DATE:	October 16, 2026
MAI NO.:	24042
OPSC APPL. NO.:	
DSA APPL. NO.:	02-123774
DSA FILE NO.:	10-126

NEW TEMPERANCE ELEMENTARY SCHOOL

SANGER UNIFIED SCHOOL DISTRICT
SANGER, FRESNO COUNTY, CALIFORNIA

ADDENDUM NO. 3

TITLE
BUILDING 500
FIRE PROTECTION
PIPING PLAN

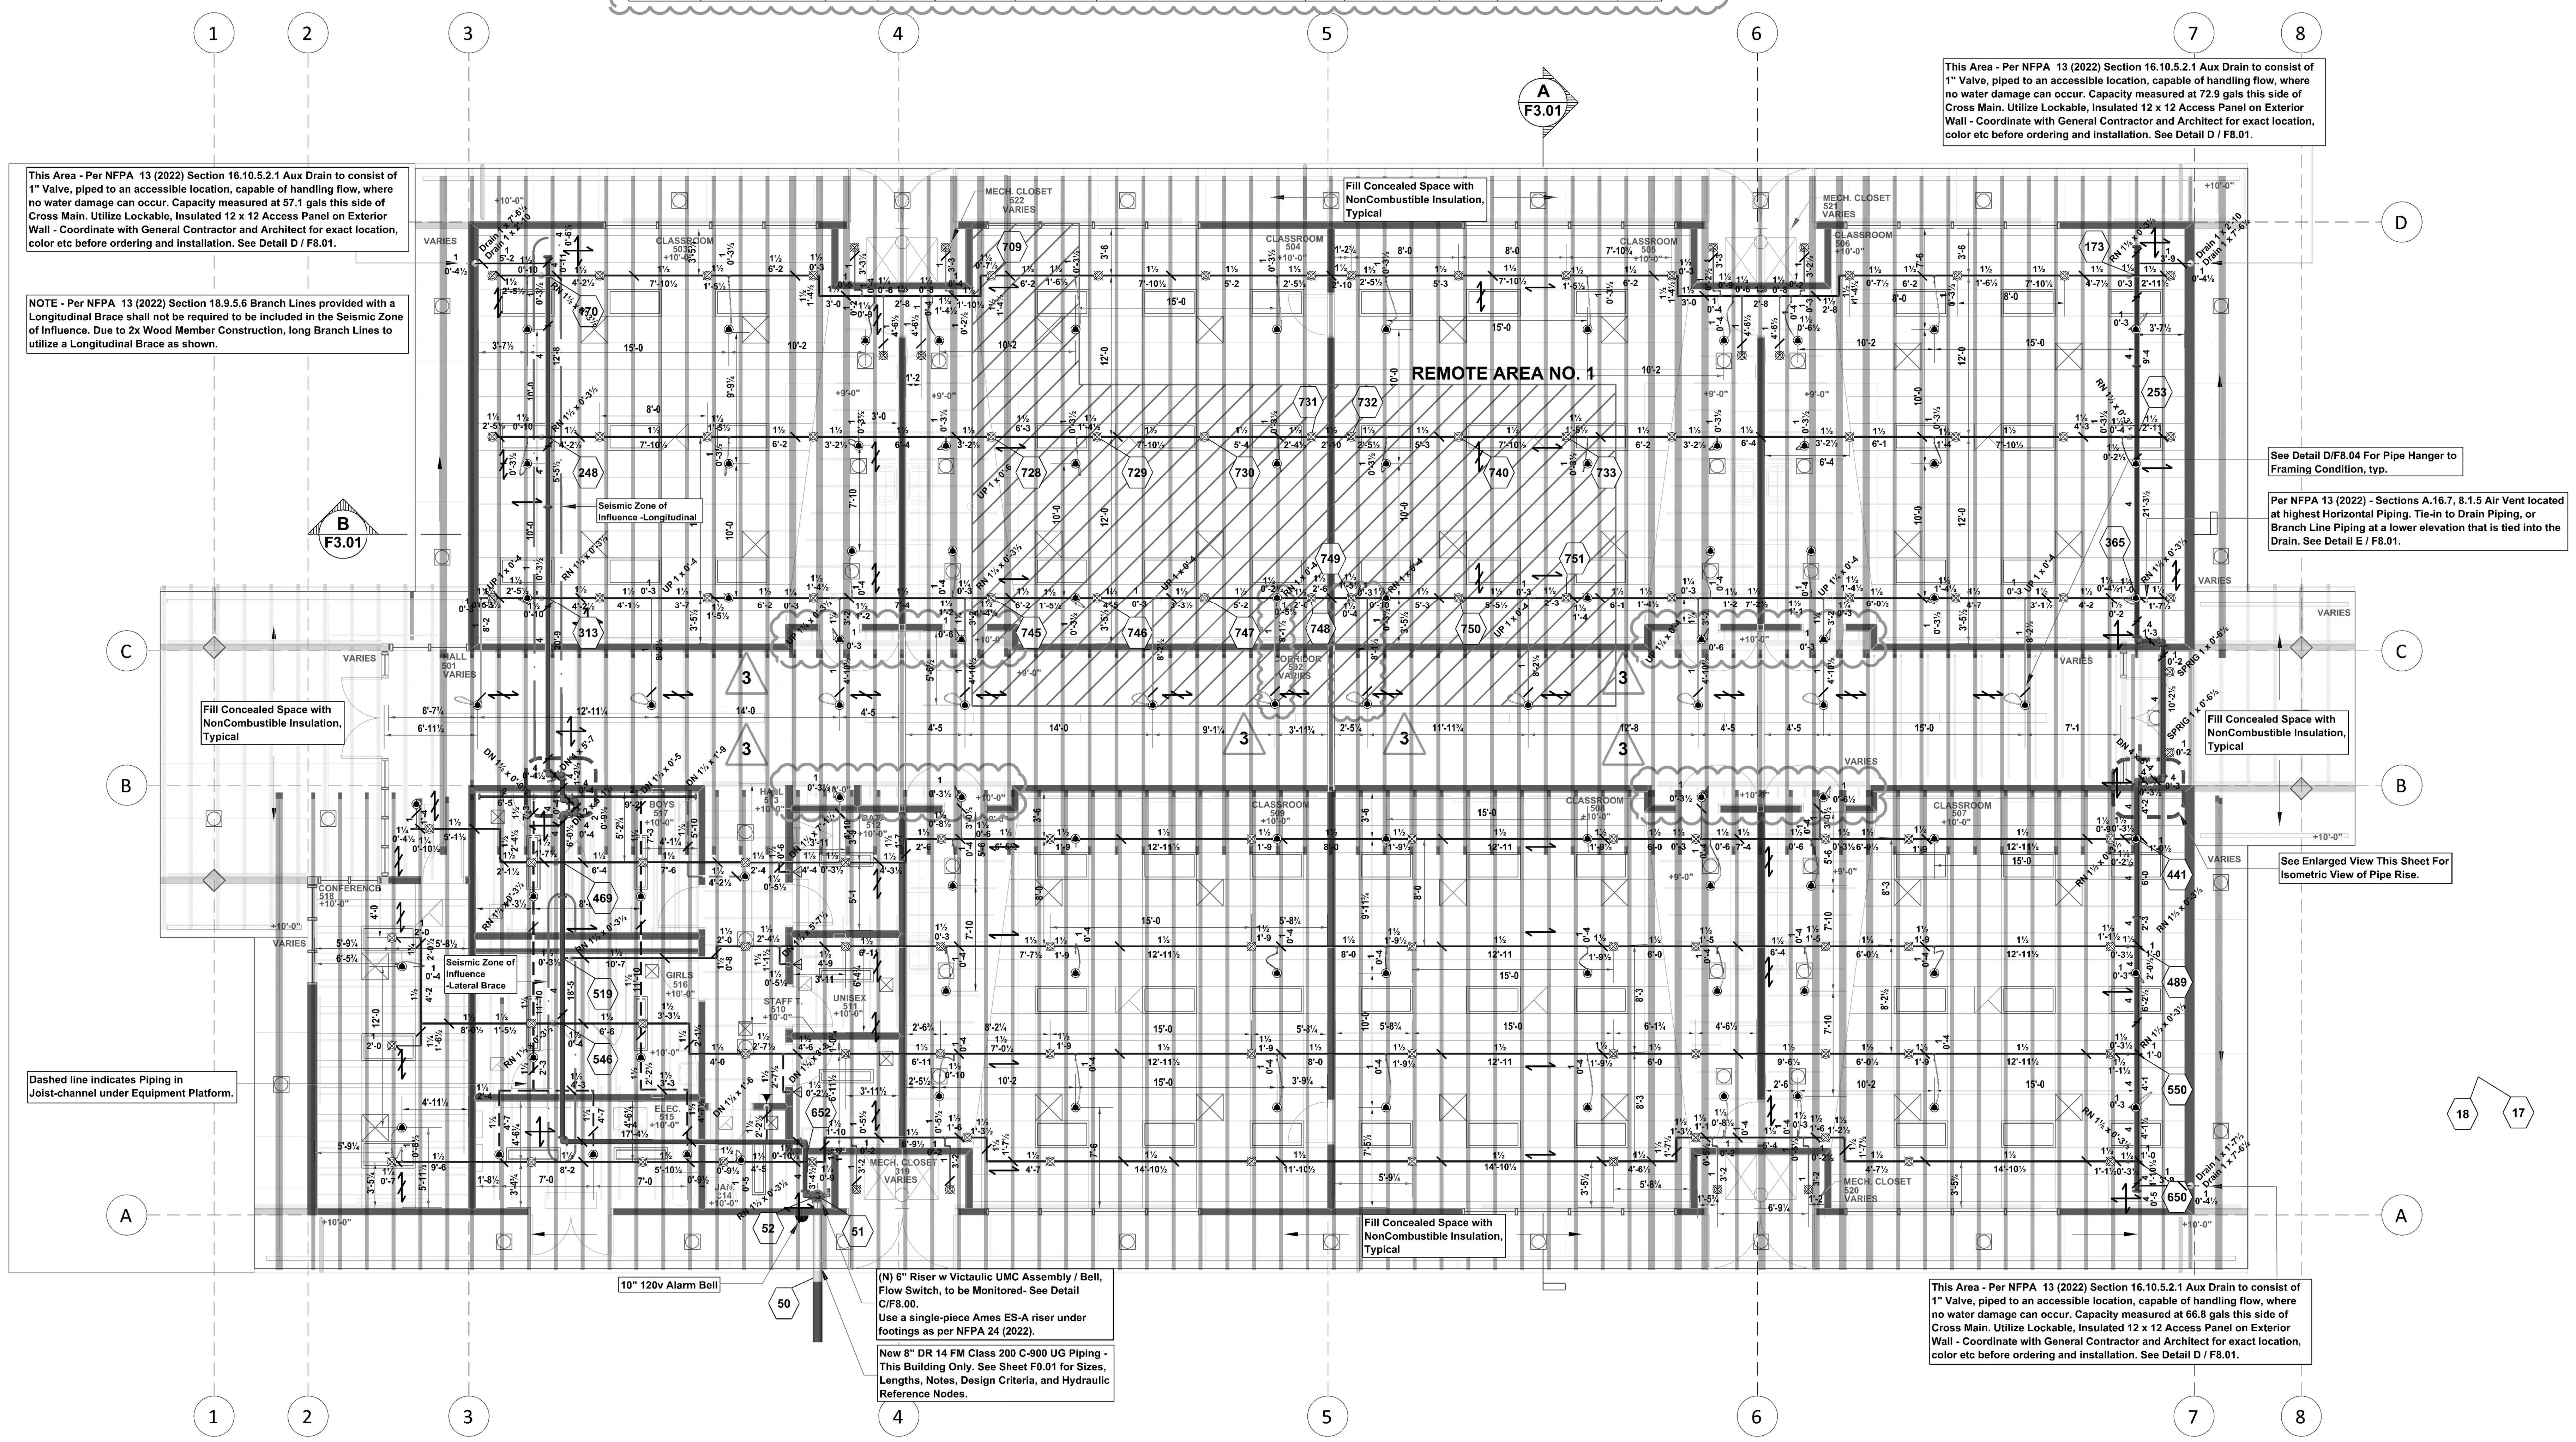
4.1. **REPLACE** sheet F5.00 with the F5.00 sheet attached to this letter.
        4.1.1. A total of (8) Pendent Sprinklers to (4) small Alcoves were added in Hallway 502.

4.1.2. Relocated (4) Armovers w / Pendent Sprinklers, and added (1) additional Pendent Sprinkler in Hallway 502.
